STATE OF MISSOURI  
DEPARTMENT OF NATURAL RESOURCES

DIVISION OF ENVIRONMENTAL QUALITY

October 28, 1986

Mr. James A. Rode, Plant Manager  
Combustion Engineering, Inc.  
P.O. Box 107  
Highway P  
Hematite, MO 63047

OUTFALL: 001 PERMIT NO. MO-0000761  
 PREPARED BY: VP DATE: 10/23/86

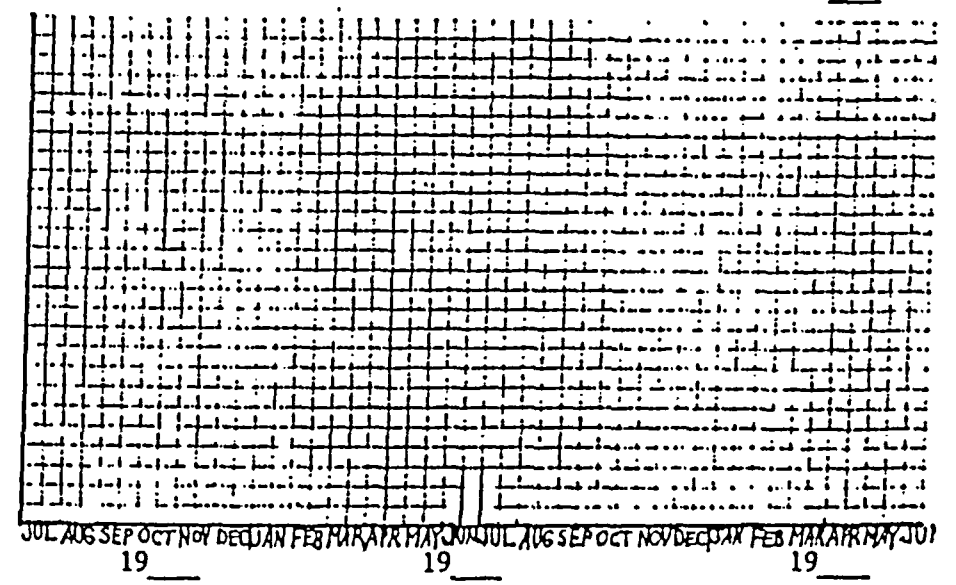
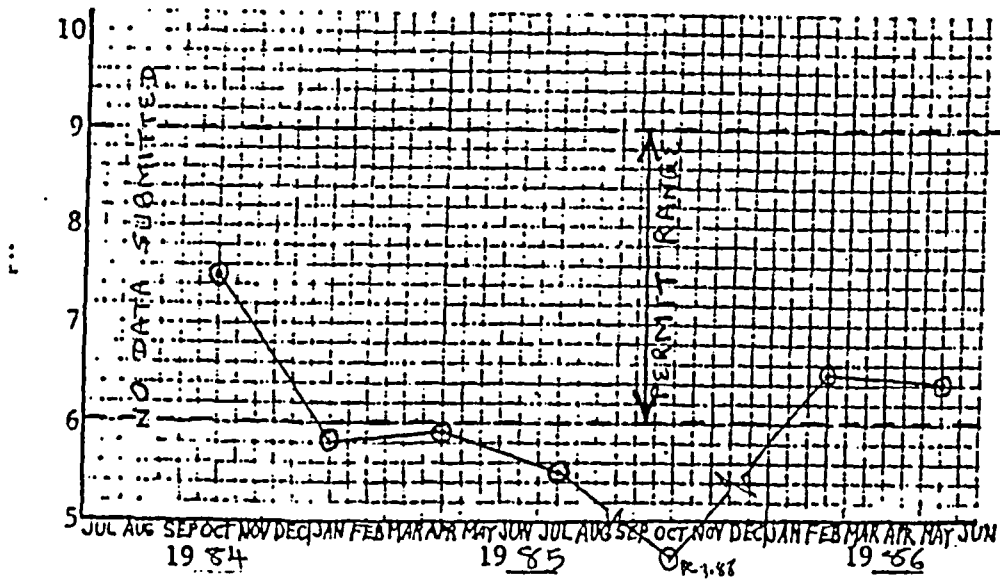
6. The discharge monitoring reports indicated that effluent violations occurred in four of eight quarters for which they were reviewed. These included four violations of the permitted limits for pH at outfall #001 and one violation of the permitted limit for fluoride at outfall #002.

Effluent data for the period reviewed have been plotted on graphs which are attached to this report. Dashed lines on the graphs indicate the limits applicable to this discharge. The frequency of noncompliance, the range of exceedances and the frequency of missing data can readily be determined from the graphs. For outfall #001, one BOD exceedance occurred 5% over the monthly average limit and four pH violations below the minimum permitted pH have occurred. Compliance with fecal coliform limitation could not be ascertained since the effluent monitoring data were not submitted for this parameter. No exceedances were noted for total suspended solids.

1. Waste sludge from the mechanical sewage treatment plant per the recommendations contained in the operation and maintenance manual.
2. Clean the clarifier weir on a regular basis.
3. Submit the additional information requested for the permit reissuance.
4. Report fecal coliform analyses results on discharge monitoring reports for outfall #001 during the period April 1 through October 31.
5. Submit the discharge monitoring report for the third quarter of 1984 for outfall #001.
6. Include sample collection data and type of sample collected on the discharge monitoring reports.
7. Take appropriate steps to achieve consistent compliance with the permit effluent limitations.

OUTFALL: 002 PERMIT NO. M10-0000761  
 PREPARED BY: VP DATE: 10/23/86

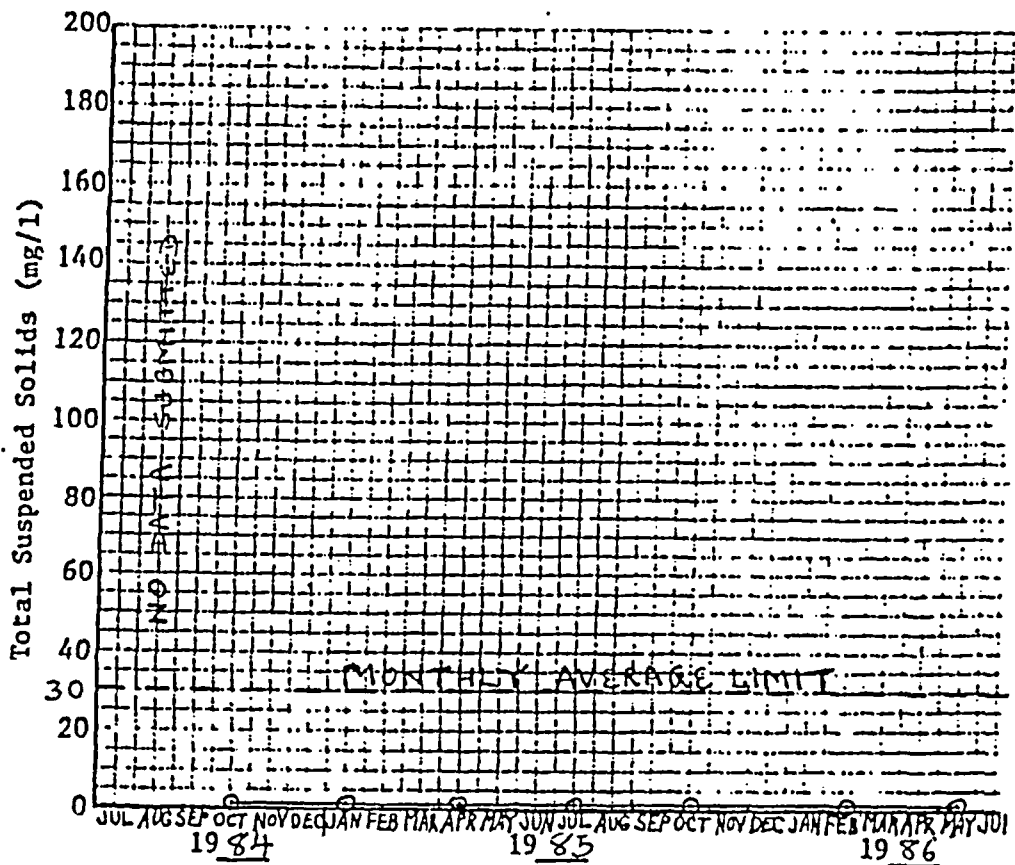
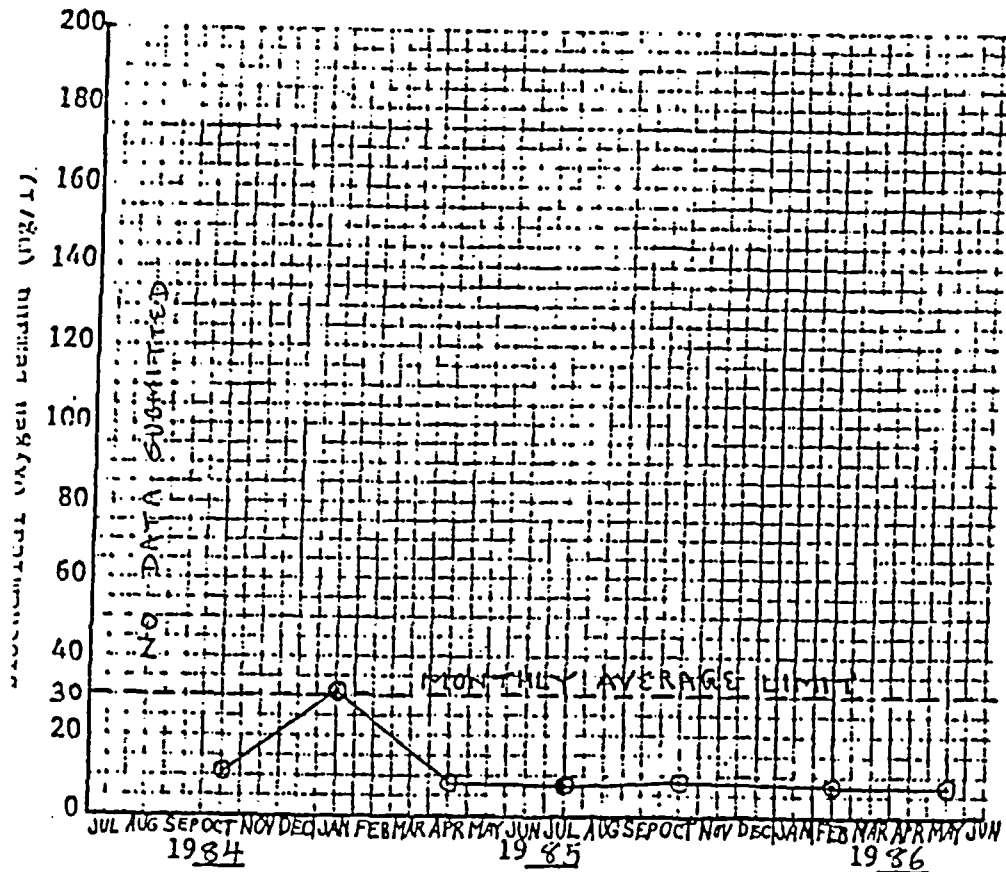
For outfall #002, one fluoride exceedance occurred 58% above the monthly average limit. No exceedances were noted for total suspended solids, oil and grease, and pH for outfall #002.
